Issue to resolve

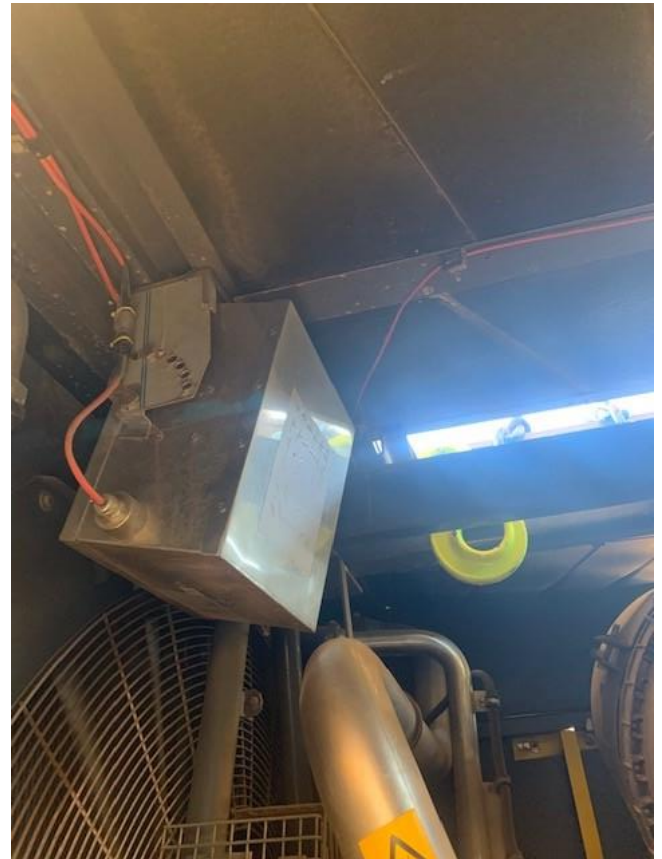
- Resolve mounting location for FP Unit – not as per drawing
- Resolve Mounting Location for Panel – not as per drawing
- Plastic Cover over Control Panel
- Suggest change battery to FP-08872 NiMh
